ICDS Grapple Retention Retrofit Solution

Alert

Model: See Affected Equipment	Apr. 22, 2022	
Serial #: N/A		
Alert

Figure 3

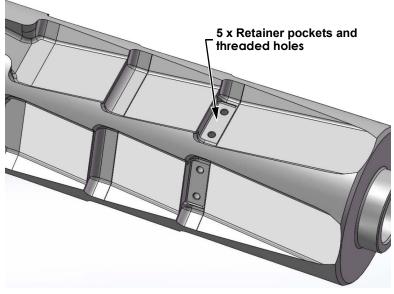
2. Modification of 'on-hand' Mandrel(s) – P/N: 15406, 15406-1 or 15406-2 – See Figure 3.

- Machine the slots, drill and thread the holes as per P/N: 5101761 Mandrel, 9-5/8" Modified for grapple retention.
- Refer to Appendix A for drawing 5101761.
- 3. Modification of 'on hand' Grapples (all grapple sizes 9-5/8" to 13-3/8") qty. 5 per set See Figure 4.

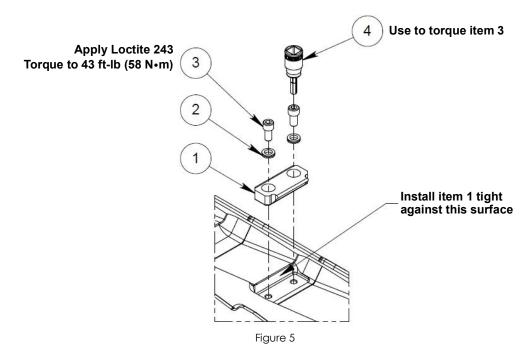
- 5. Assemble P/N: 5101763 Grapple Retainers (qty. 5) on the modified mandrel.
 - Refer to Figure 5 for the assembling detail.

- Apply Loctite #243 to the screws.
- Ensure the correct orientation of the Grapple Retainer.
- Ensure the proper installation of the Nord-Lock washers.
- Ensure the retainer is tight to the one surface of the pocket before the bolts are tighten. See Figure 6:

• Use P/N: 5101759 – Allen Bit socket and appropriate Torque Wrench to tighten the screws to 43 ft-lb.

Appendix B – P/N: 5101762 – Grapple, 9-5/8" to 13-3/8", Modified for Retention

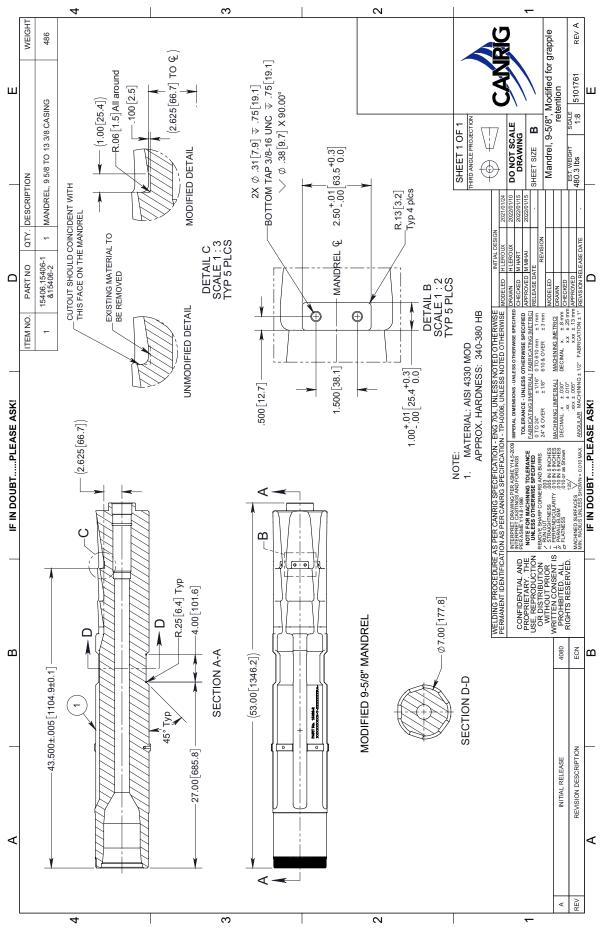
- If it is determined that the grapples are still serviceable, modify the grapples as per P/N: 5101762 Grapple, 9-5/8" to 13-3/8", Modified for retention.
- Refer to Appendix B for drawing 5101762.
